# Preliminary Plan of Subdivision

## 4-18022

SUBJECT: Preliminary Plan of Subdivision 4-18022  
Type 1 Tree Conservation Plan TCP1-005-2019  
Dewey Property

Figure 6. Belcrest Road (Toledo Terrace to Metro Entrance) Off-Street Cycle Track Illustrative

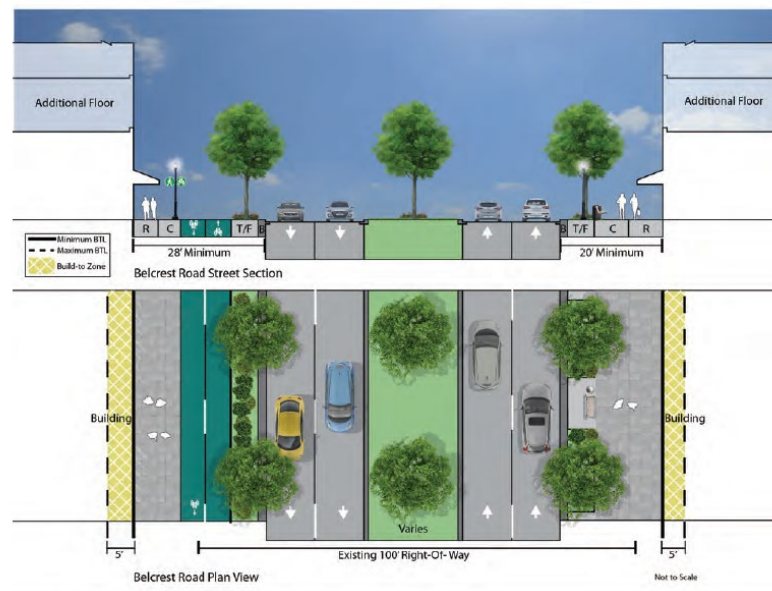
The TDDP provides the following street section for Belcrest Road:

Figure 12. Toledo Road (Existing) Illustrative Street Section

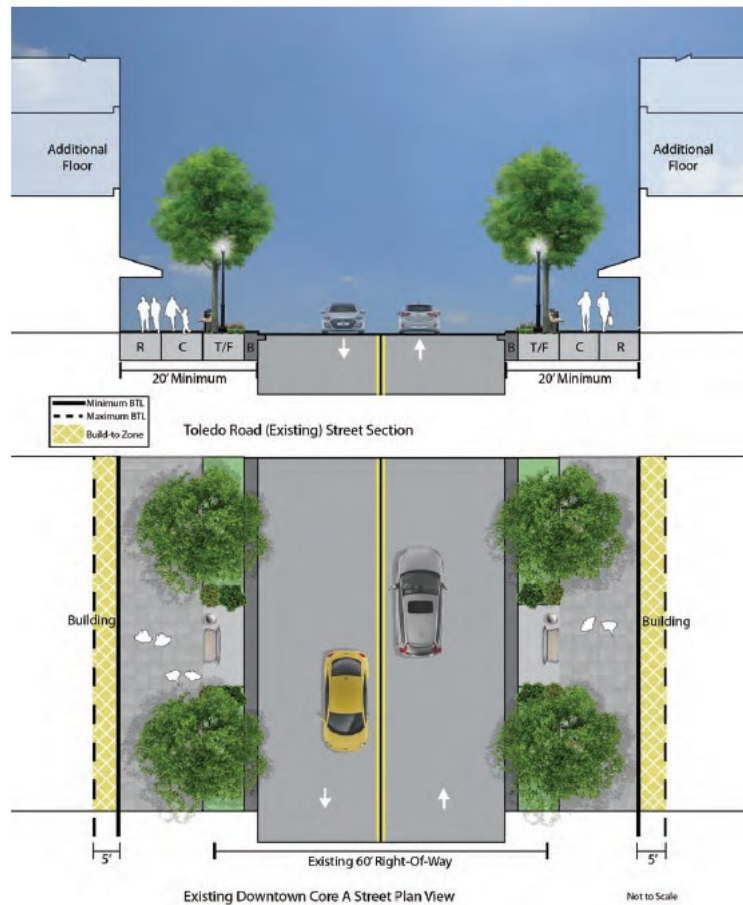
The TDDP provides the following street section for Toledo Road:
